Subject: FW: Comments to Council for New Community Area Block 27 Secondary Plan Study File # 26.4.1.
Attachments: Block27PlanJun19-2018.pdf

Re: Letter to Council, Tuesday, June 19, 2018 at 1:00pm
New Community Area Block 27 Secondary Plan Study – File # 26.4.1

I represent the owners of 2939 Kirby Road which is located south east corner of Jane and Kirby Rd.

Block 27 - Land Use Plan

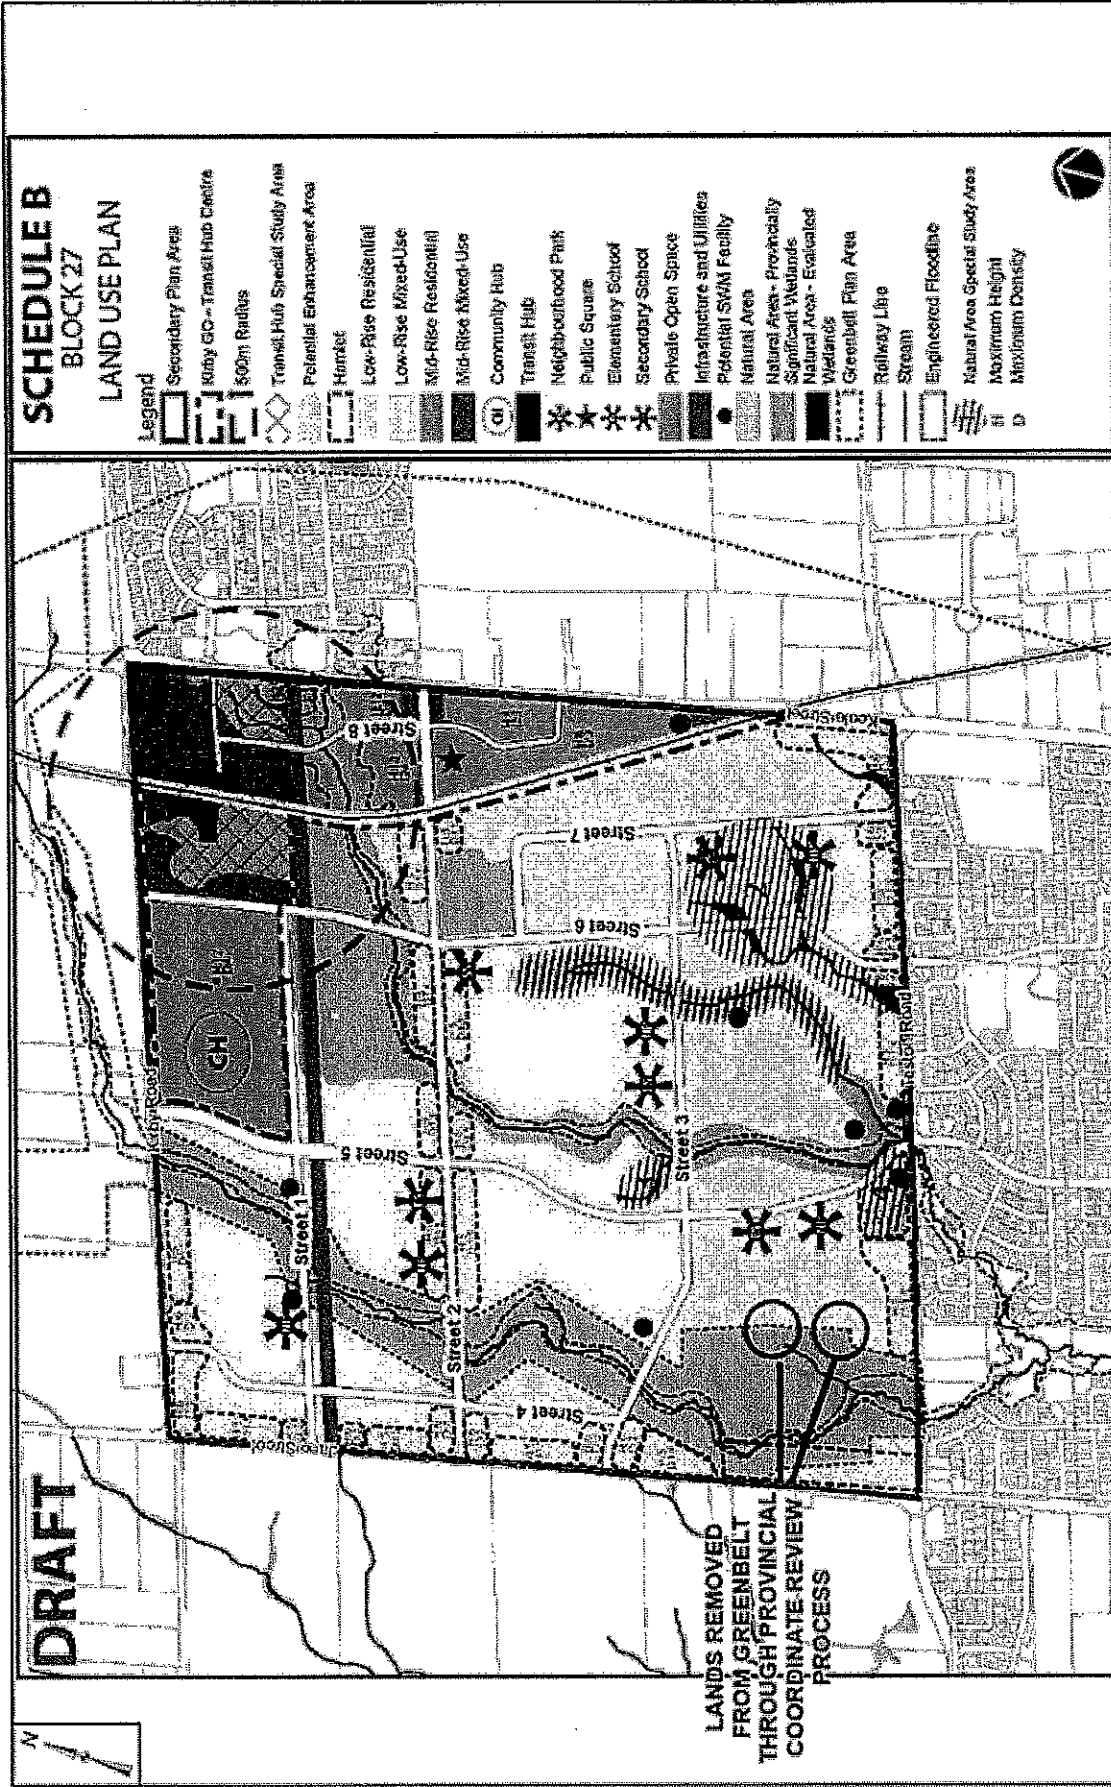
1. Major collector, Street 5 is shown with a wider road leading to arterial road, Kirby Road. This wider road is not mentioned in the policies and the other 3 Major Collector / Arterial Road connections and not shown similarly. Staff addressed this as a drafting error and to be corrected.

2. Locations for Low Rise Mixed-Use described in policies are not shown on some intersections of Major Collector / Arterial Roads. More specifically, south corner of Jane St. and Street 1 and the west corner of Street 5 and Kirby Rd. Furthermore, Low Rise Mixed use shown at Street 1 should extend to Street 4 similar to as shown on Street 3 and the other intersections with arterial roads.

3. The height and density along Jane St., near Kirby Road intersection should equal the same as shown for height and density at Keele St. and Teston Rd. intersection.

4. To clarify height and density of community hub area west of the 500m radius shown on schedule B. It is understood that the Height of 8 storeys and density of 3.0 applies to this area. Note other areas south of 500m radius do show the Height and Density.
